<b>AMENDMENT OF SOLICITATION/MODIFICATION OF CONTRACT</b>				1. CONTRACT ID CODE	PAGE 1 OF 4 PAGES
2. AMENDMENT/MODIFICATION NO. AMENDMENT NO. 0003		3. EFFECTIVE DATE 9-14-11	4. REQUISITION/PURCHASE REQ. NO.	5. PROJECT NO. (If applicable) 11-0116	
6. ISSUED BY CODE sdb  Officer in Charge of Construction MCI-East 1005 Michael Road Camp Lejeune, NC 28547-2521			7. ADMINISTERED BY (If other than Item 6) CODE  See Item 6		
8. NAME AND ADDRESS OF CONTRACTOR (No., street, county, State and ZIP Code)				(X)	9A. AMENDMENT OF SOLICITATION NO. N40085-11-R-0116
				X	9B. DATED (SEE ITEM 11) 9-8-11
CODE _____ FACILITY CODE _____					10A. MODIFICATION OF CONTRACT/ORDER NO.
					10B. DATED (SEE ITEM 11)

N40085-11-R-0116, Project # 11-0116, Repair Vehicle Maintenance Shop A2

CONTINUATION SHEET

A SITE PLAN - BUILDING A-2  
C-1 C-1 SCALE: 1"=20'

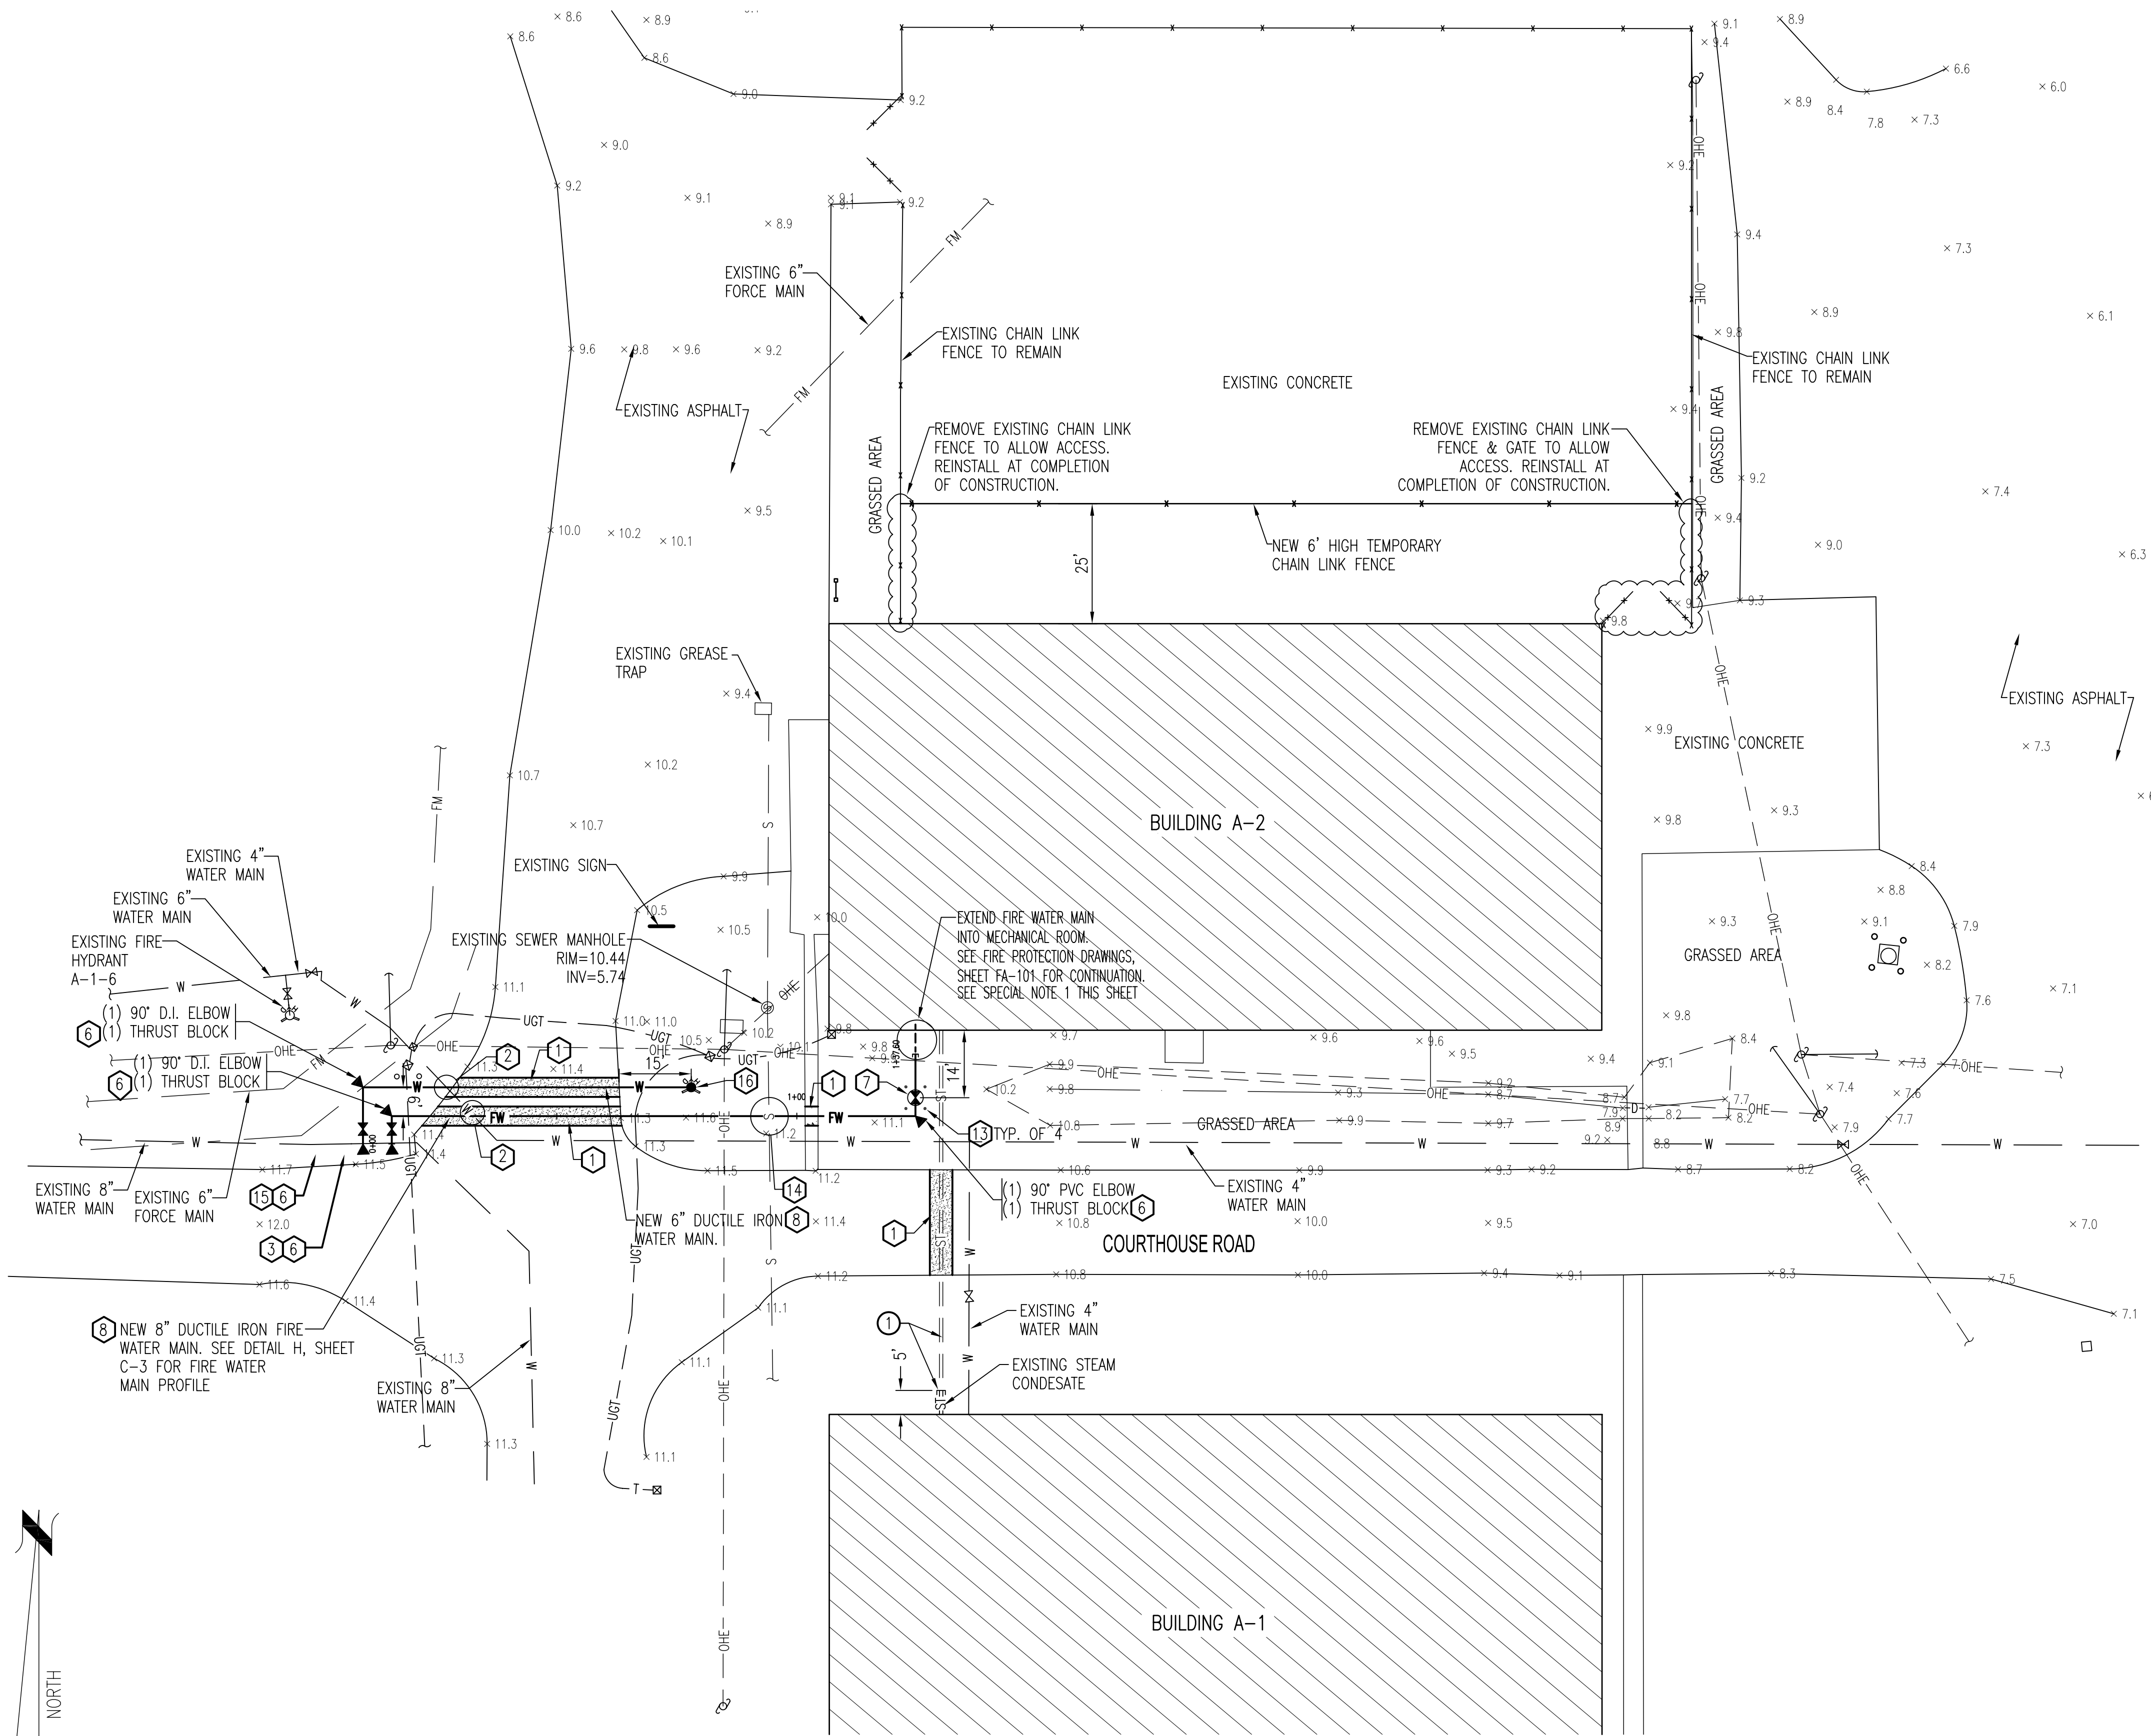
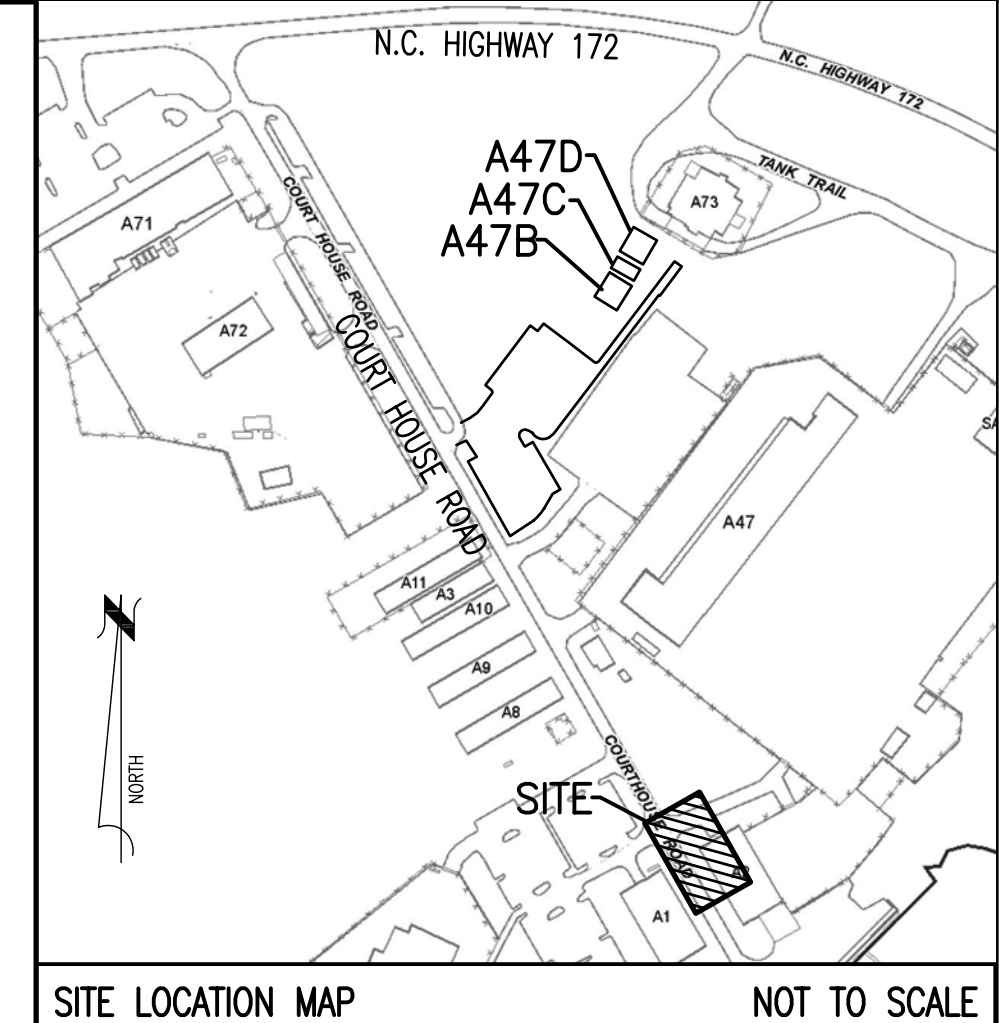
2. QUESTION: Plans indicate an approximately 8" wide foundation to be put under the new masonry walls. This does not appear wide enough to allow installation of the #4 bars to be installed into the existing slab edge.

ANSWER: The trench in the floor for the footing is shown to be nom. 8". The #4 bars are shown to be 7" long with 3" imbedment into the existing slab edge.

The following revised civil drawings C-1 (60008849) and C-3 (60008851) are hereby incorporated.

REVISIONS			
SYM	DATE	APPROVED	
1	ADD HYDRANT	9/14/11	JKA

- NEW 8" x 6" TAPPING SADDLE & VALVE - SEE DETAIL C, SHEET C-3 AND SPECIFICATIONS.
  - NEW FIRE HYDRANT - SEE DETAIL L, SHEET C-3.

L FIRE HYDRANT ASSEMBLY  
C-1 C-3 NOT TO SCALE

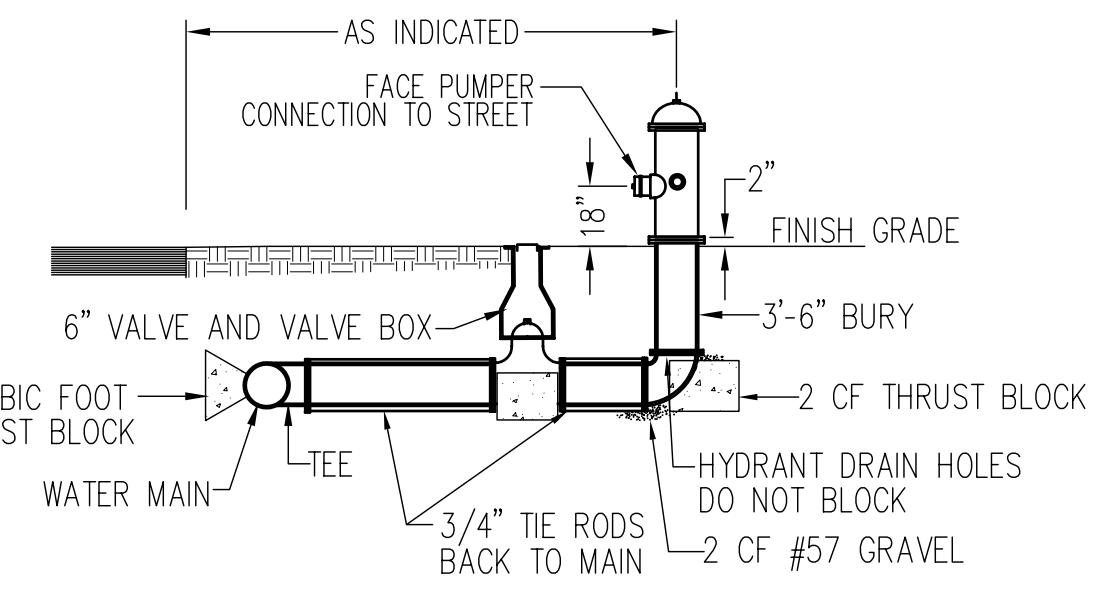
REVISIONS			
SYM	DATE	APPROVED	
1	9/14/11	JKA
